# I-25 at US 50 Interchange Reconstruction (PN 23255)

Final Value Engineering Report

Colorado Department of Transportation

December 2021

# IM-03 Quantitative Value Alternative

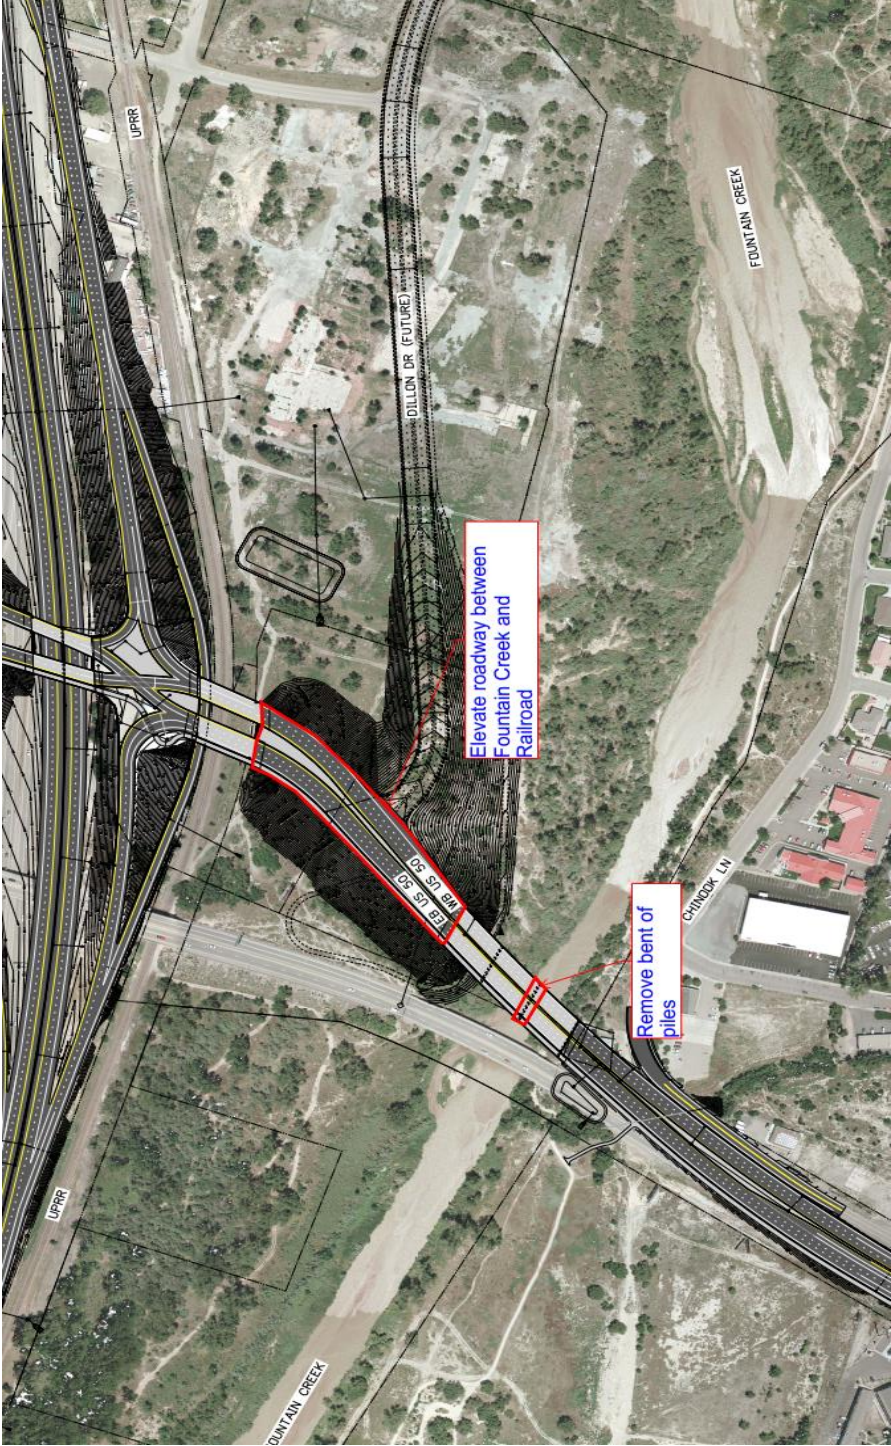
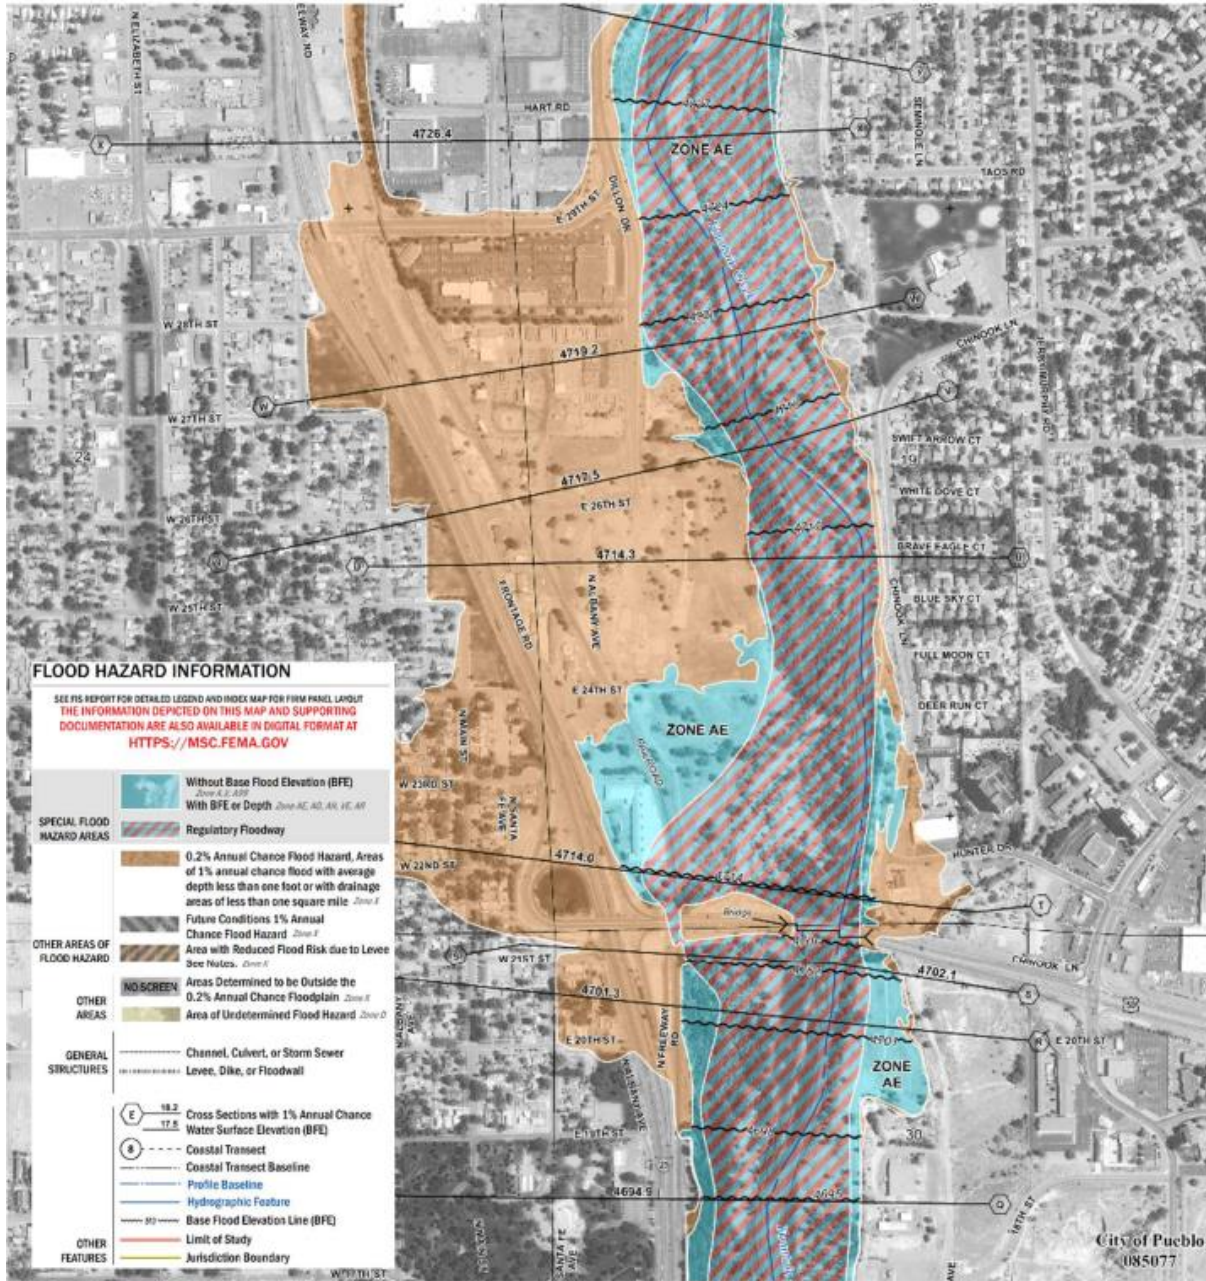
- IM-03 Continuous Bridge from Fountain Creek to UPRR; Eliminate Fill and Retaining Walls**  
A continuous bridge structure spanning the Fountain Creek floodplain and UPRR tracks would reduce impacts to the floodplain, and eliminate imported fill requirements and retaining walls. However, full structured crossing would significantly increase construction costs.

The Alternative Concept is to remove the earthen roadway and replace it with an elevated roadway between the bridges that crosses Fountain Creek and the railroad. The span that crosses Fountain Creek will be lengthened to remove the piles that are currently proposed to be placed within Fountain Creek.

- Increase costs for elevated structures and bridges.
- Increase costs for lengthening the span over Fountain Creek

The impact of adding the proposed fill in the floodway / floodplain is a major concern. The proposed elevated roadway would likely remove the concern and likely reduce the floodway and floodplain width. The removal of the proposed piers from the channel of Fountain Creek will likely improve the hydraulics of the creek from the Original Concept.

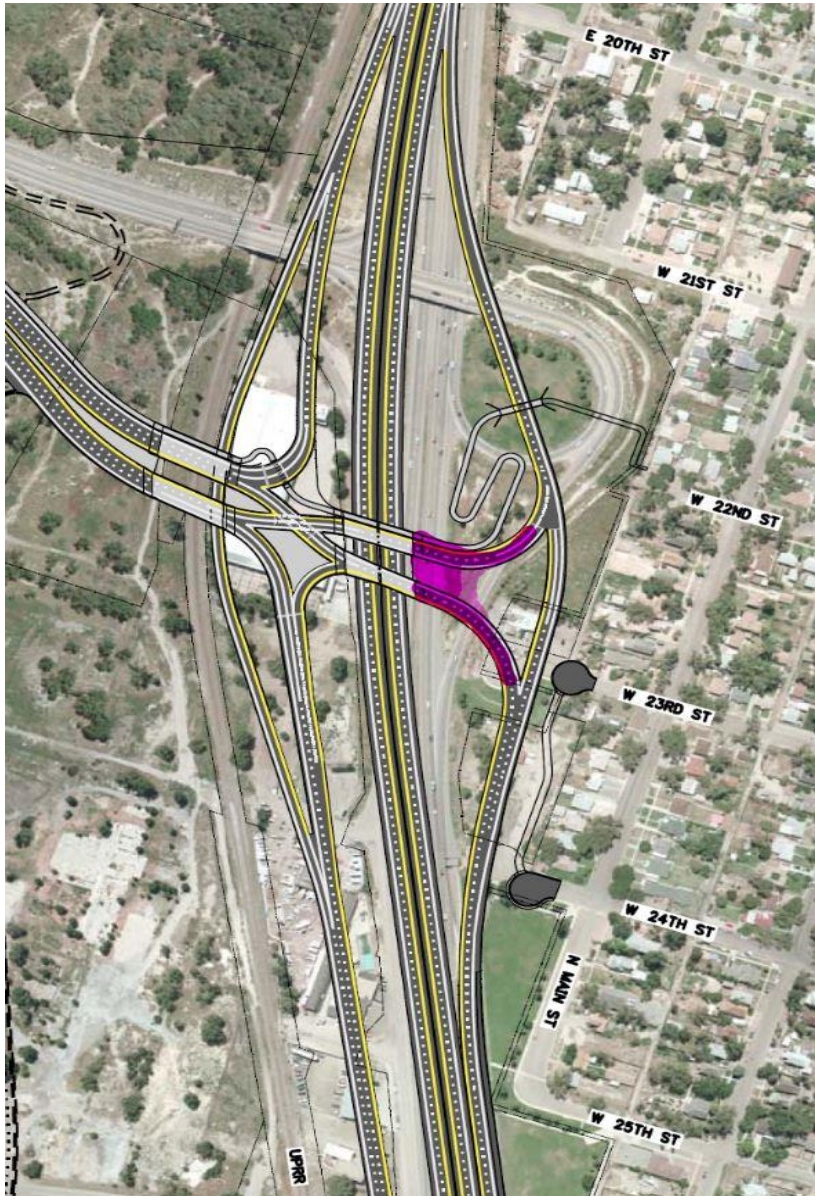
- MM-07 Utilize Geofoam or Styrene Backfill**  
Alternative backfill materials such as styrene or geofoam would reduce import requirements, which in turn reduces construction traffic and roadway wear along the approaches to the project. Construction schedule can be improved. CDOT and other agencies have previously used geofoam for backfill on highway construction projects. However, alternative backfill materials are sensitive to sunlight (ultraviolet) and petroleum solvents, and construction costs would likely increase.

The west abutments of the bridges over I-25 are expected to have consolidation settlement issue. Pre-loading, wick-drain installation, and waiting period may be required. BY utilizing the geofoam materials, the settlement will be decreased, and minimize or eliminate the needs for pre-loading, wick drains or waiting period. This would shorten the construction time, and allow the new roadway to open earlier. This can also be applied in other embankment area to shorten the construction time.

## PE-12 Quantitative Value Alternative

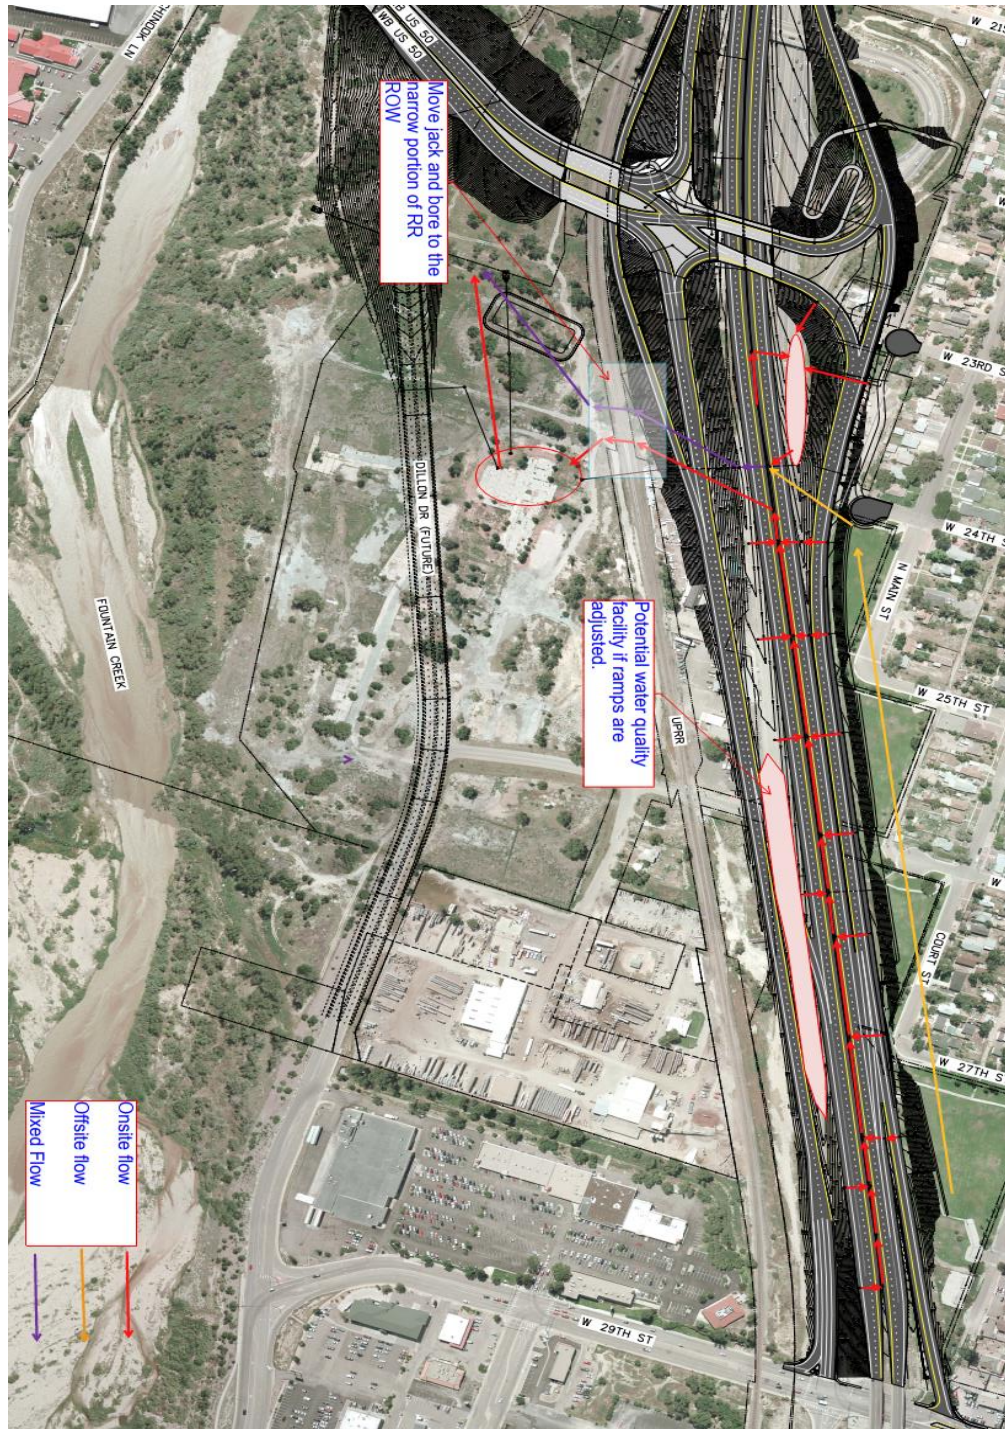
- PE-12 Evaluate Water Quality Opportunities on West Side of Corridor and Separate Offsite Flows**  
Inclusion of additional water quality basins or features within the project would increase the volume of on-site storm water runoff treatment before discharge, and may reduce construction costs. However, an additional jack-and-bore beneath the UPRR tracks would be required, and off-site drainage would not be treated before discharge.

- Introduces an additional jack and bore under the railroad
- Does not overtreat the northern area.
- May not provide significant cost savings.
- May require additional water quality locations.

The quantities were roughly calculated and summarized below. The total benefit to the project financially saves the project \$30,400. The reductions of the Original Concept water quality facility and the Alternative Concept water quality facility are assumed to be net neutral cost savings. However, the benefit of not treating off-site flows and allowing CDOT to transfer the four ponds on the west side of I-25 is a benefit that can't be financially quantified.

# PE-17 Quantitative Value Alternative

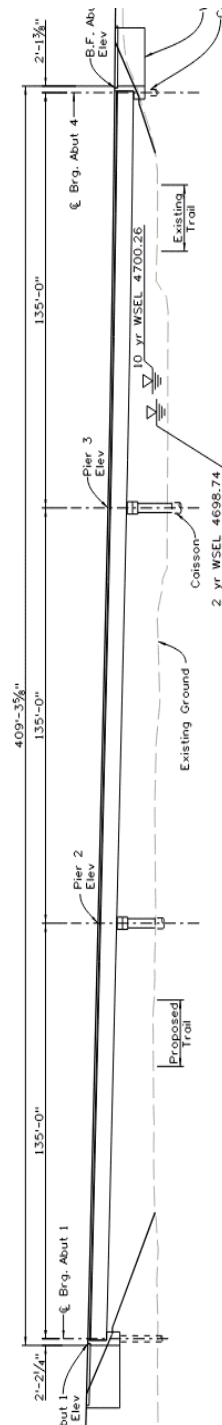
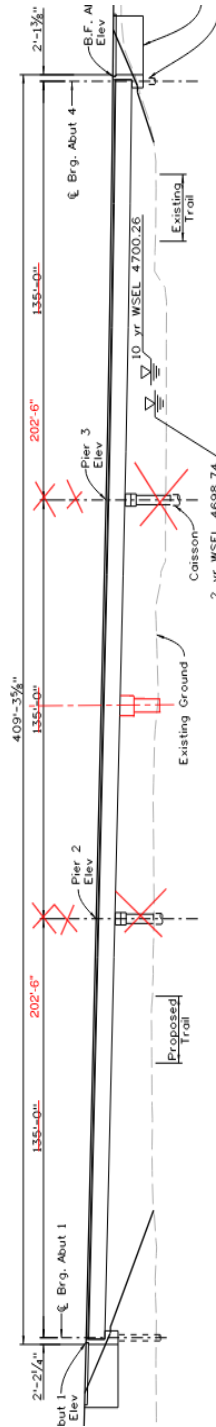
- PE-17 Eliminate Pier Within Fountain Creek; Provide Two-Span Bridge Structure**  
Eliminating the US 50 bridge structure support pier within Fountain Creek would reduce impacts to the floodplain associated with construction activities and avoid future scour related maintenance requirements. However, longer spans would be required which would increase structure depth thereby reducing freeboard over Fountain Creek. However, construction costs would increase.

- Increase superstructure costs for longer spans.
- Deeper superstructure, reduced freeboard.

The impact of constructing a set piers in Fountain Creek is a major concern. The removal of the proposed piers from the channel of Fountain Creek will likely improve the hydraulics of the creek from the Original Concept.

| ID No.                | Alternative Title  | Alter. Cat. | Mut. Excl. | Incl. (i) | Potential Costs (\$) |          |                 | Cons. Dec. | Consensus Comments   | Key Alter. | Decision Makers |
|-----------------------|--|-------------|------------|-----------|----------------------|----------|-----------------|------------|--|------------|-----------------|
| <a href="#">PE-17</a> | Eliminate Pier Within Fountain Creek; Provide Two-Span Bridge Structure  | Qlt(-)      | IM-03      | i         | \$ (2,170,400)       | \$ -     | \$ (2,170,400)  | FS         | Design team will investigate further to determine viability. |            | Owner, Designer |
